INTERNAL CORRESPONDENCE

SUBJECT: ECO Matrix and rework for IPB, IOC, DRR Boards REV 3

This document contains the rework required to up-grade the IOC, IPB, DRR Channel and interface boards to the latest correct dash and REV level.

699A (CONT'D) PW13 1001242-04 REV. 8 & 11 ONLY

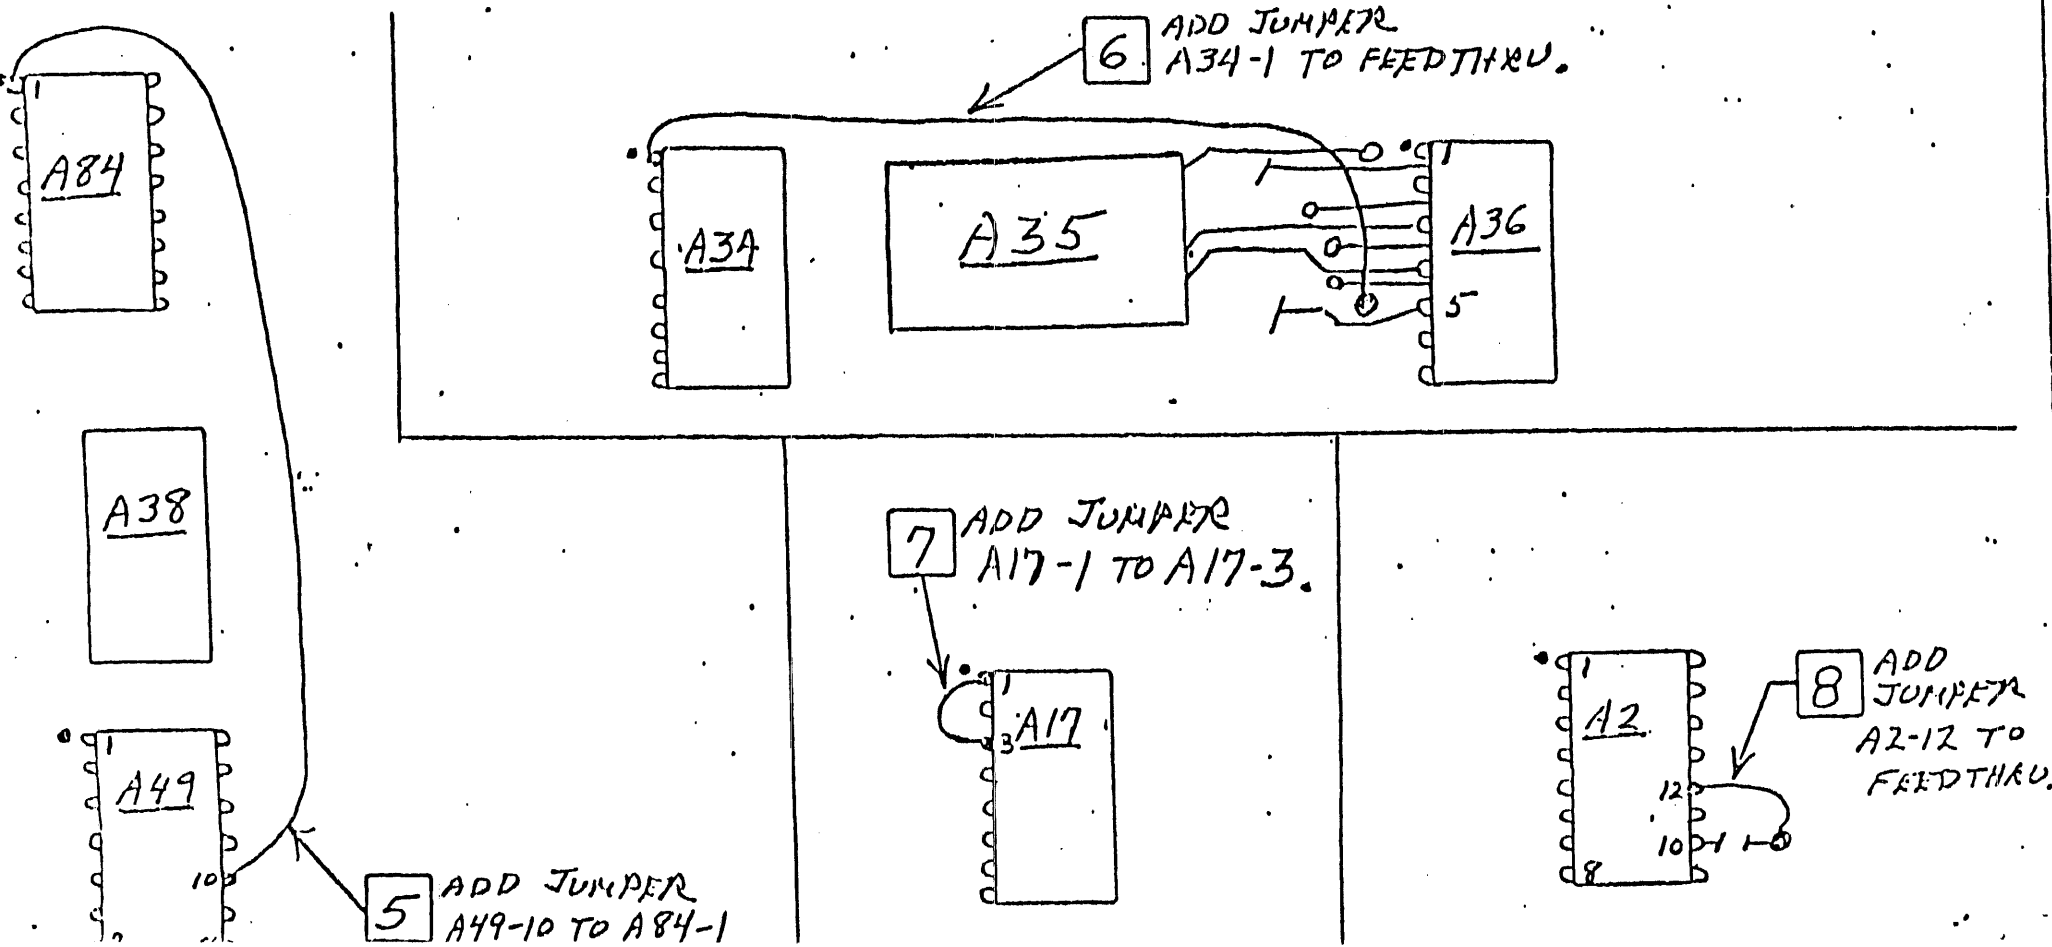
- STEP 5 ADD JUMPER FROM A49-10 TO A84-1. (COMPONENT SIDE).
- STEP 6 ADD JUMPER FROM A34-1 TO FEED THRU ADJACENT TO A36-5 (COMP. SIDE).
- STEP 7 ADD JUMPER FROM A17-1 TO A17-3 (COMPONENT SIDE).
- STEP 8 ADD JUMPER FROM FEEDTHRU ADJACENT TO A2-10 TO A2-12 (COMP. SIDE).
- STEP 9 ADD JUMPER FROM A6-11 TO J18-16 (SOLDER SIDE).
- STEP 10 ADD JUMPER FROM A6-12 & 13 TO A1-39 (SOLDER SIDE).

2699A (CONT'D) PWB 1001242-04 REV. 8 & 11 ONLY.

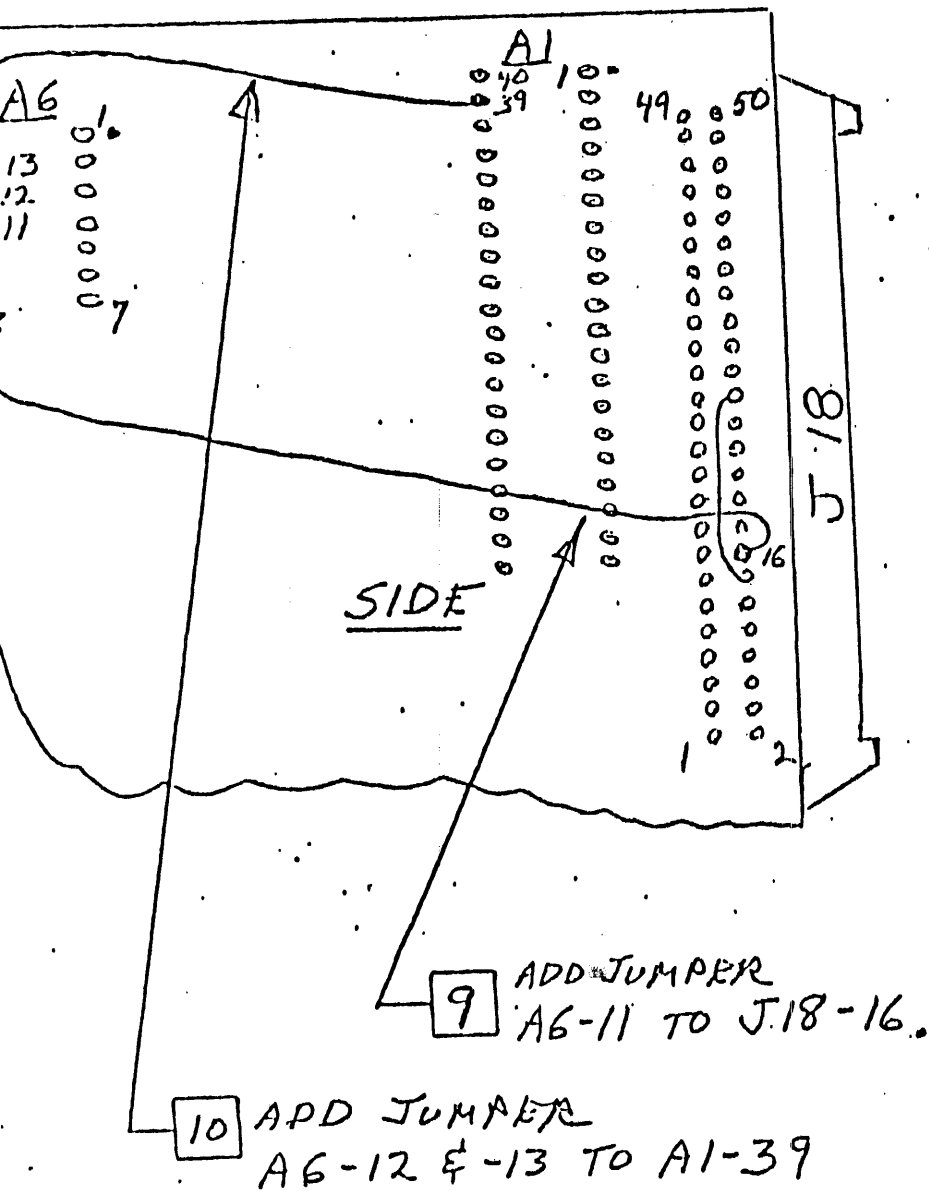
STEP 11 ADD (1EA) 470 Ω RESISTOR
P/N 56-019 FROM A68-6 TO
A68-16 (COMPONENT SIDE).

11 ADD 470 OHM RESISTOR
(56-019) A68-6 TO A68-16

REWORK INSTRUCTION: (CONT'D)ECO 2699 A (CONT'D) NOTE: FOR 1001242-04 REV. 8, 11, 12 & 13.

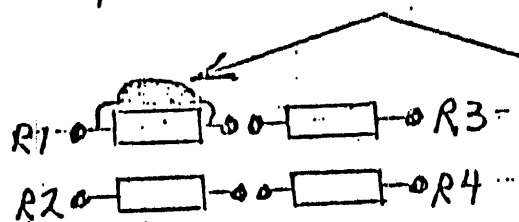
STEP 12 ADD CAPACITOR C-90 IN PARALLEL TO RESISTOR R1.
P/N. 64-007 CAP. CER, .01UF $\pm \frac{80}{20}\%$ 25V.

12 ADD CAPACITOR IN
PARALLEL TO R1

ECO 1630 - PWA 101241-04 REV. 12 TO REV. 13, USING PWB 1001242-04 REV 8.

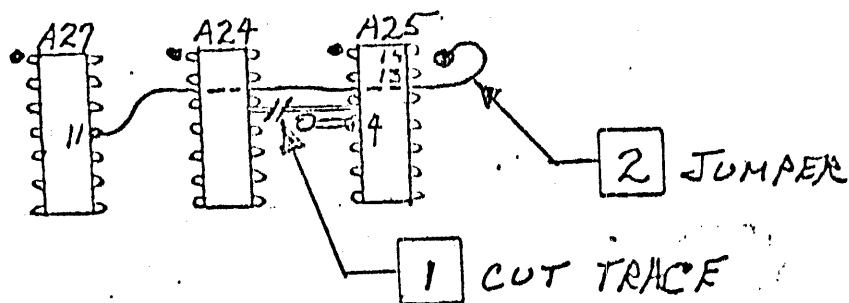
- STEP **1** CUT TRACE ABOVE FEEDTHRU BESIDE A25-4 (COMPONENT SIDE).
 STEP **2**, ADD JUMPER FROM A27-11 TO FEEDTHRU BESIDE A25-13 (COMP. SIDE),
 RUNNING WIRE UNDER A24 & A25.

- STEP **3** MARK ECO 1630 ON SOLDER SIDE OF BOARD.

2.699A (CONT'D) PW13 1001242-04 REV. 8 & 11 ONLY

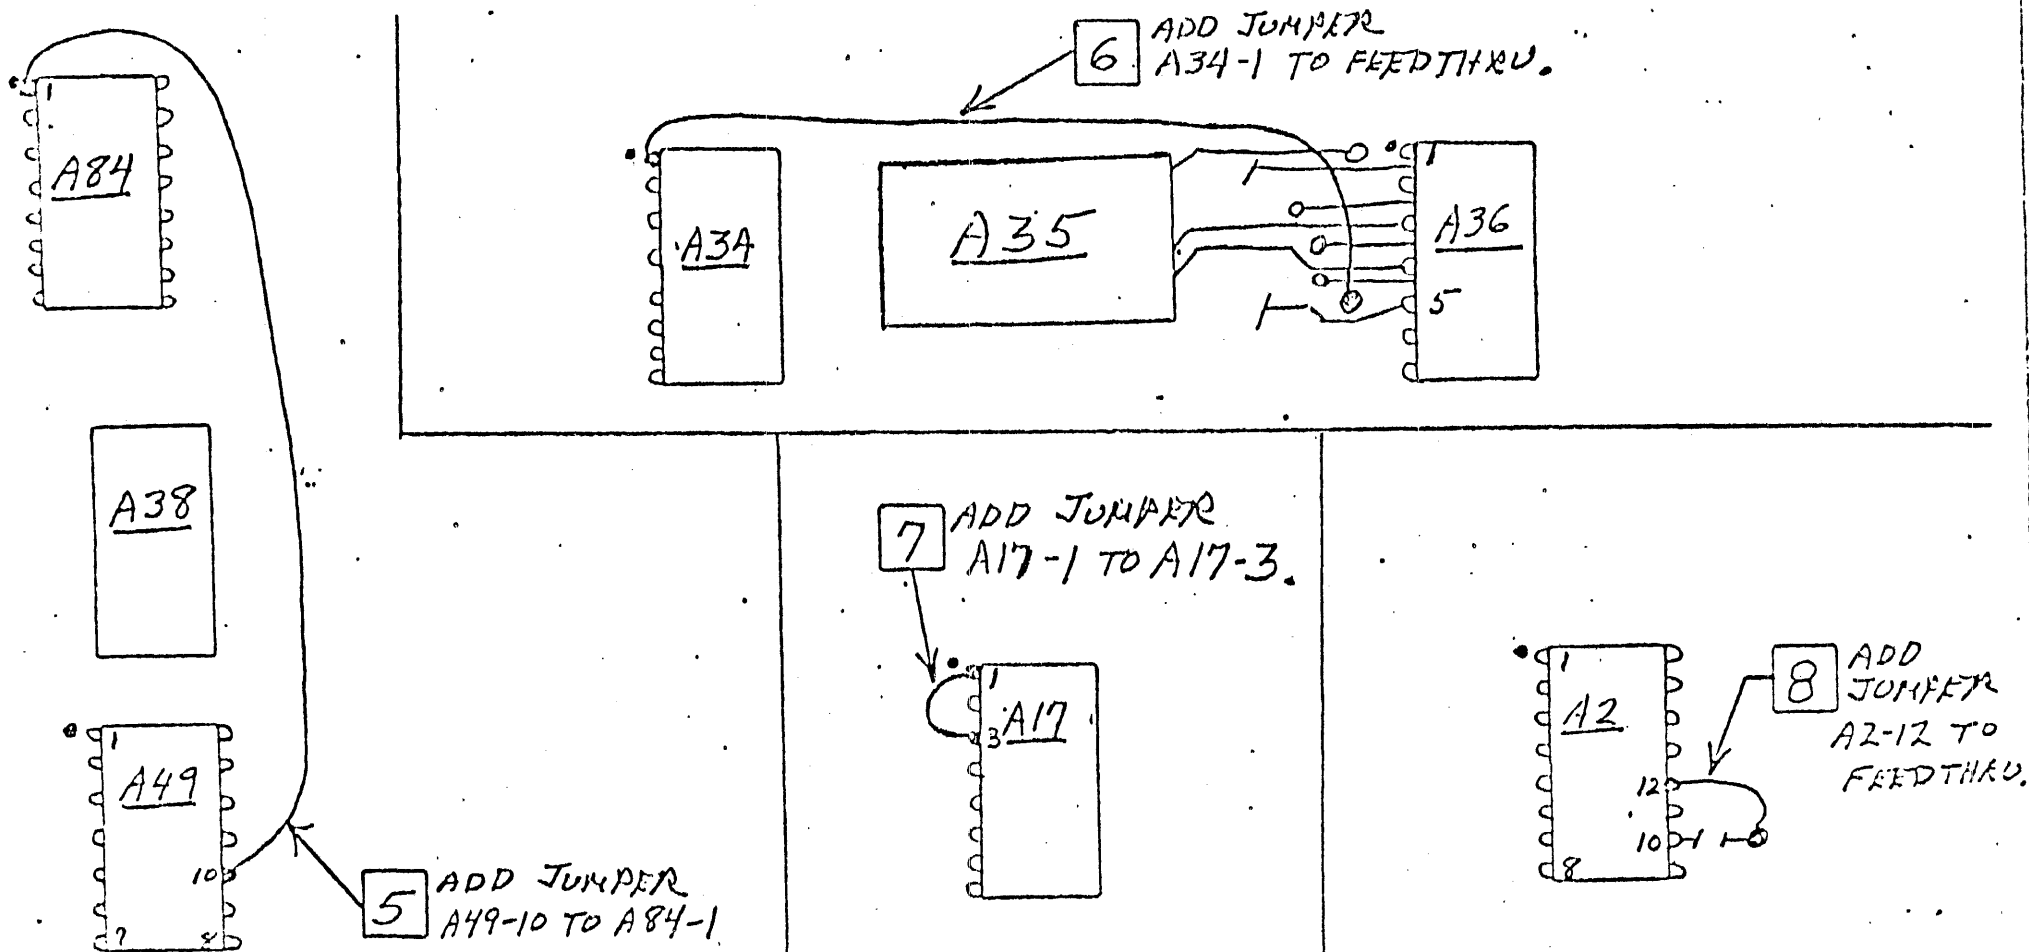
- STEP 5 ADD JUMPER FROM A49-10 TO A84-1. (COMPONENT SIDE).
- STEP 6 ADD JUMPER FROM A34-1 TO FEED THRU ADJACENT TO A36-5 (COMP. SIDE).
- STEP 7 ADD JUMPER FROM A17-1 TO A17-3 (COMPONENT SIDE).
- STEP 8 ADD JUMPER FROM FEEDTHRU ADJACENT TO A2-10 TO A2-12 (COMP. SIDE).
- STEP 9 ADD JUMPER FROM A6-11 TO J18-16 (SOLDER SIDE).
- STEP 10 ADD JUMPER FROM A6-12 & 13 TO A1-39 (SOLDER SIDE).

2699A (CONT'D) PWB 1001242-04 REV. 8 & 11 ONLY.

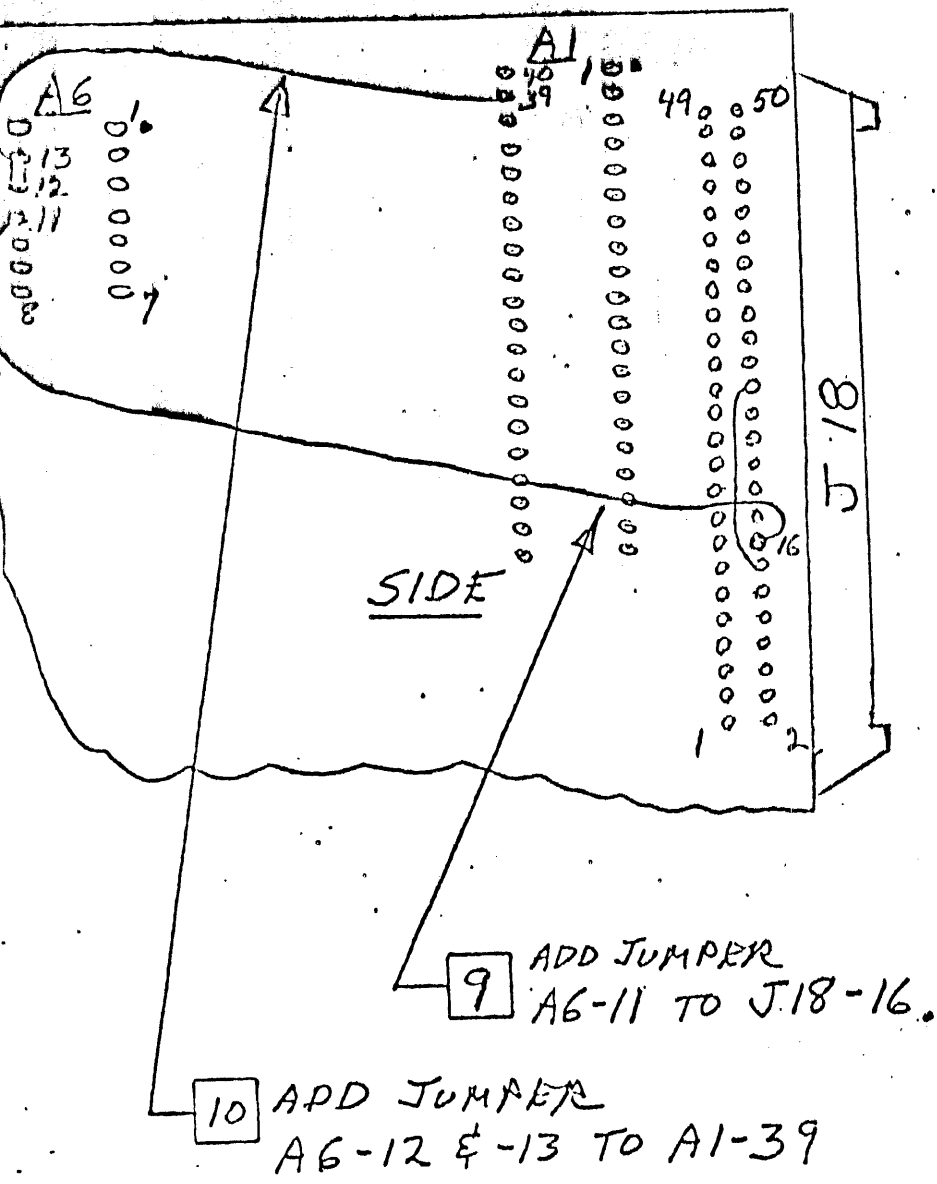
STEP 11 ADD (1EA) 470 Ω RESISTOR
P/N 56-019 FROM A68-6 TO
A68-16 (COMPONENT SIDE).

11 ADD 470 OHM RESISTOR
(56-019) A68-6 TO A68-16

ECO 2699 A (CONT'D) NOTE: FOR 1001242-04 REV. 8, 11, 12 & 13.

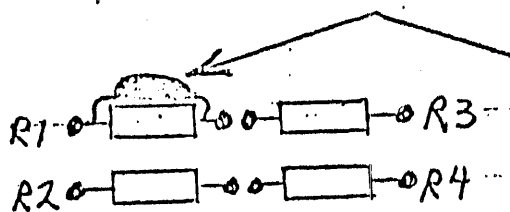
STEP 12 ADD CAPACITOR C-90 IN PARALLEL TO RESISTOR R1.
P/N. 64-007 CAP. CER, .01UF $\pm 80\%$ 25V.

12 ADD CAPACITOR IN.
PARALLEL TO R1
